8. Well Name and No.
GOLD RUSH 29 FEDERAL 2

9. API Well No.
30-015-34081-00-S1

COG Operating LLC respectfully request to abandon the Brushy Canyon and recomplete up hole to the Bell Canyon in the Gold Rush 29 Federal #2.

Gold Rush 29 Federal 2
30-015-34081
COG Operating, LLC.
May 05, 2014
Conditions of Approval

Proposed Wellbore

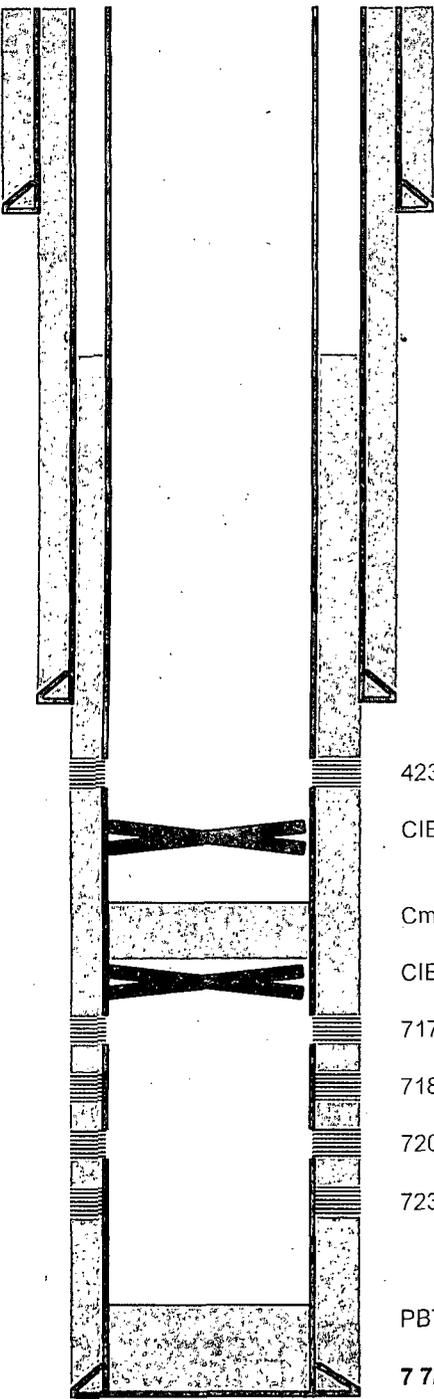
CIBP @ 4500'

Cmt Plug 7100'-7150'

CIBP @ 7150'

1. **Operator shall set a CIBP at 7,122' and place 25 sx Class C cement on top. Tag required at a minimum of 6,950'.**
2. **CIBP at 4,500' is okay.**
3. **Must conduct a casing integrity test before perforating and fracturing. Submit results to BLM. The CIT is to be performed on the production casing to max treating pressure. Notify BLM if test fails.**
